Public Review Draft  
February 2008

Proposed Revisions for  
ASME A17.1b-200x ADDENDA  
To  
ASME A17.1-2007, Safety Code for Elevators and Escalators

**TN 02-2268**

Delete Fig G1 and G2 and insert the following new Fig. G1 through G5.

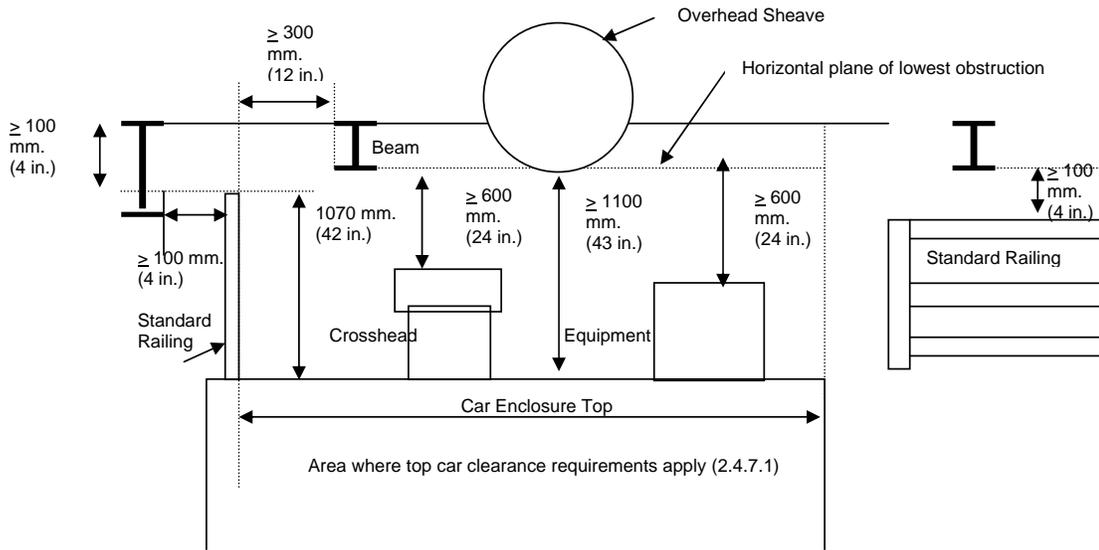
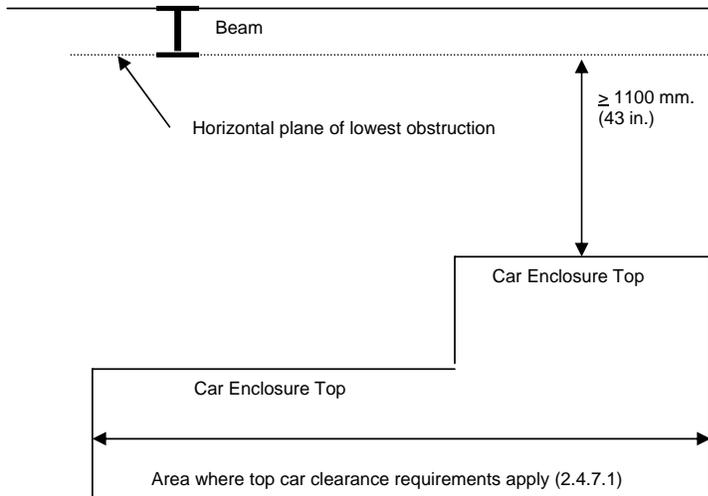
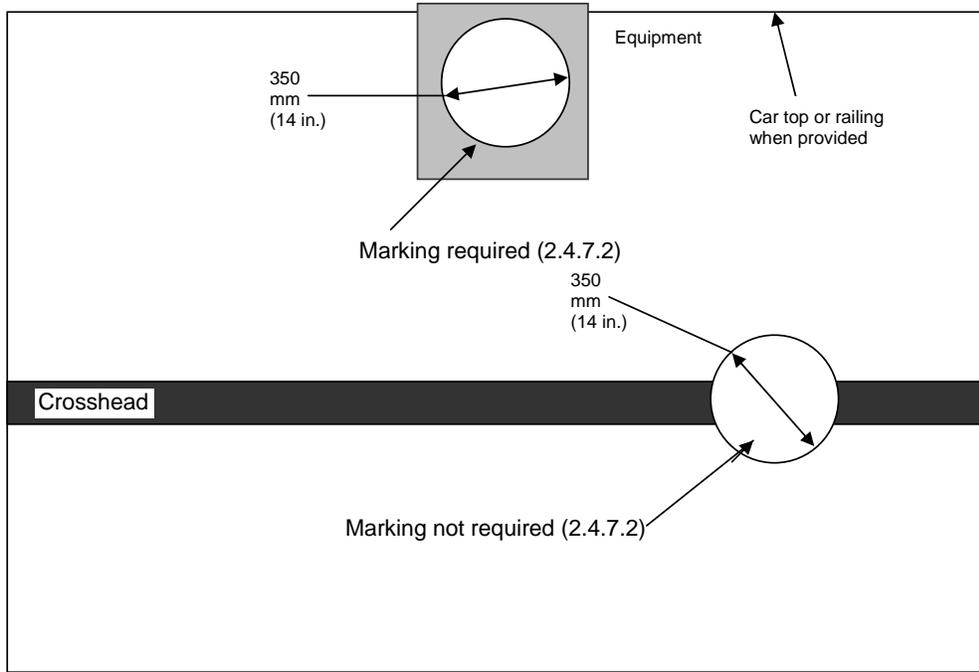
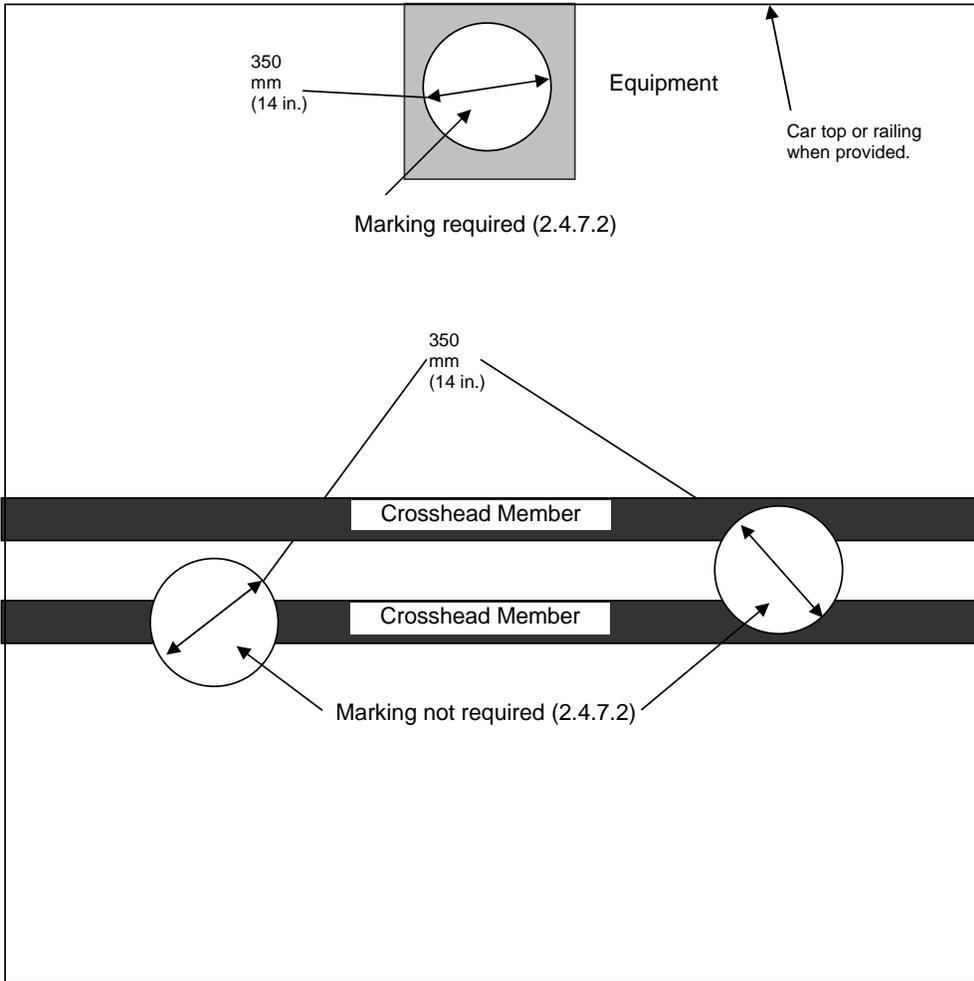
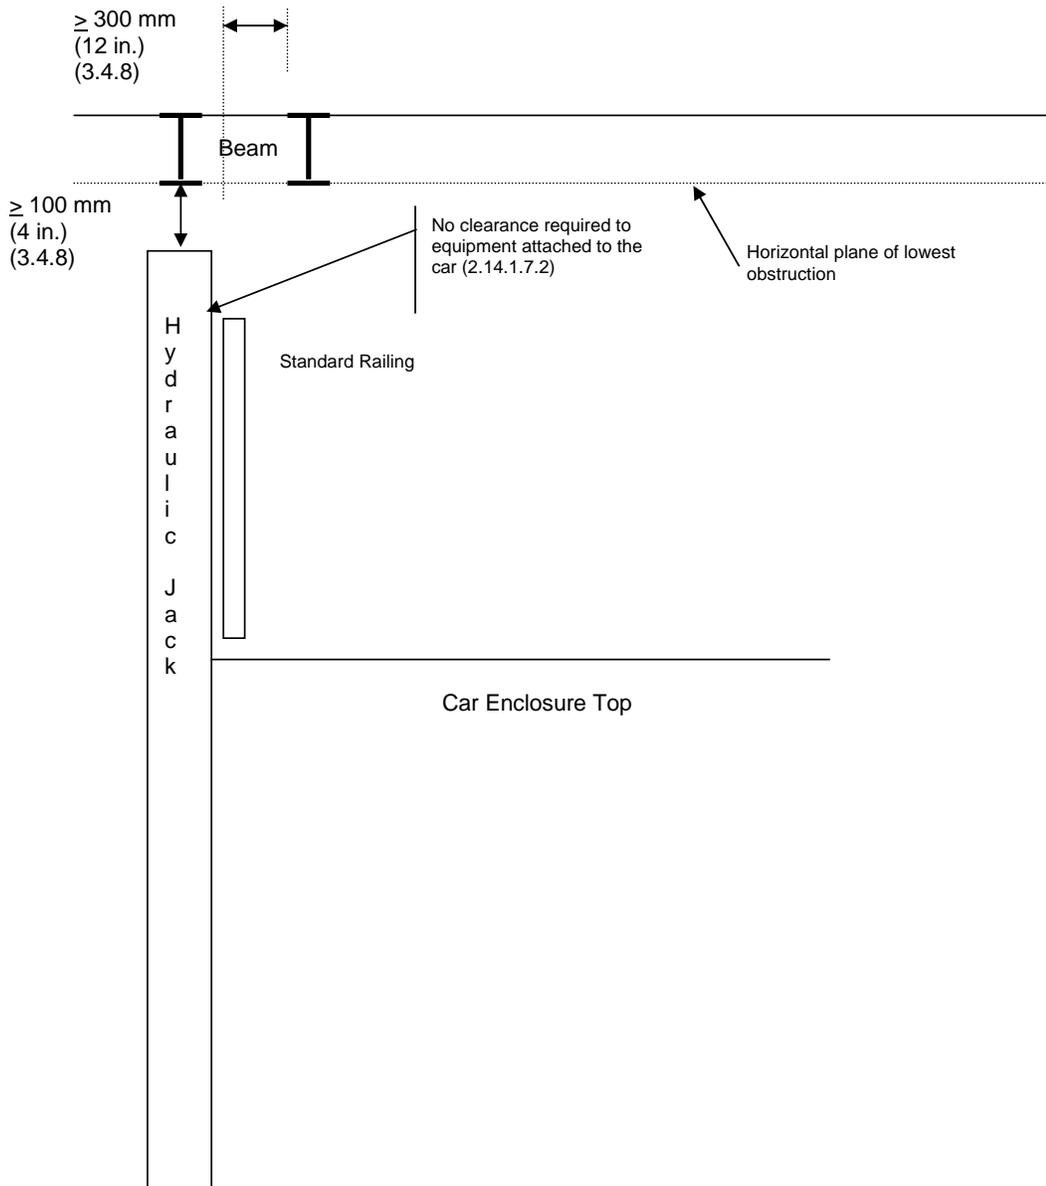
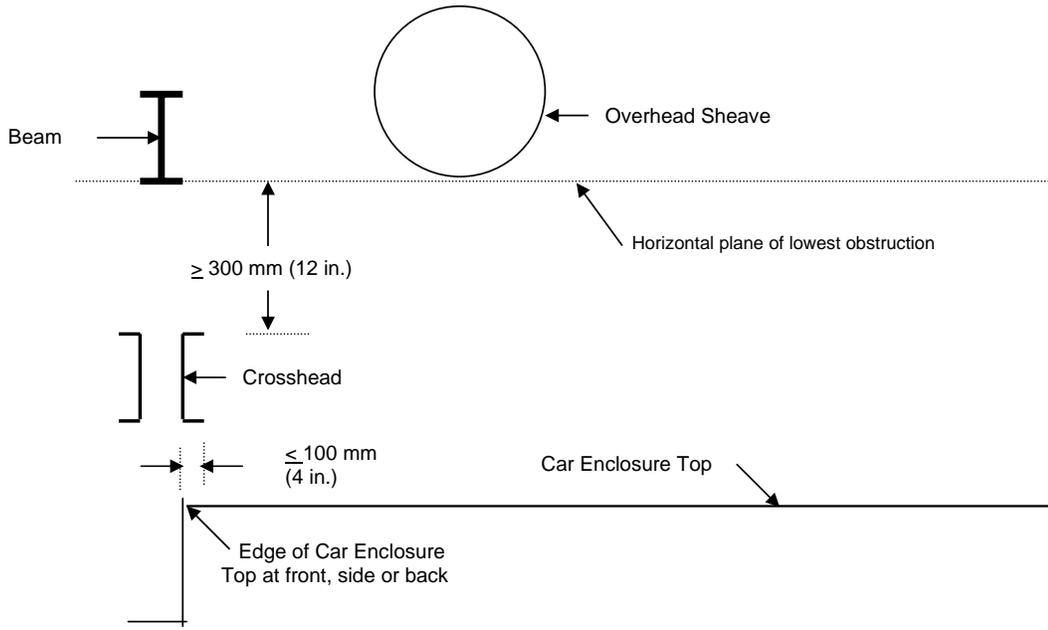
Revise **Nonmandatory Appendix G** as follows:

**Fig. I-12 Clearance between Escalator Steps**

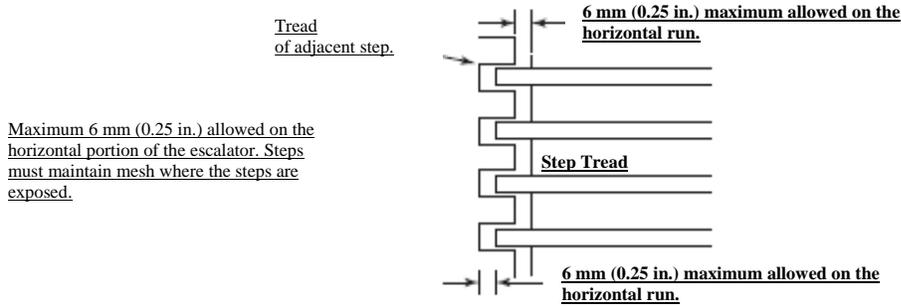
**6.1.3.5.4 Clearance Between Steps.** The maximum clearance between step treads on the horizontal run shall be 6mm (0.25 in.). (See Nonmandatory Appendix I, Fig. I-12)

**Rationale:** to add correct figure in Appendix I. 6.1.3.5.4 Clearance Between Steps – Refers to Appendix I, Fig. I-6. Propose that we develop a diagram and place it in Appendix I as Fig. I-12.

*Proposed Revision to A17.1 – 2007, Appendix I, Figure I-7 Escalator Step Tread:*

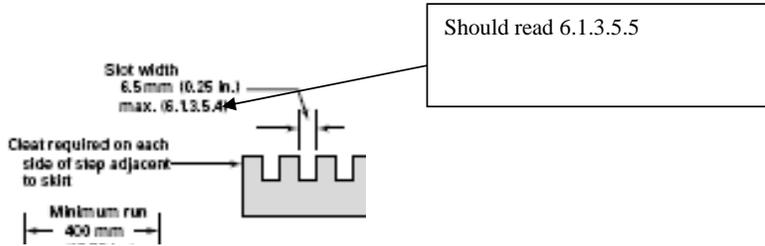
**Background:** *The reference in the slot width as 6.1.3.5.4 is incorrect. 6.1.3.5.4 refers to the distance between adjacent steps. The correct reference is 6.1.3.5.5*

**Rationale:** *to correct reference in Fig. I-7.*
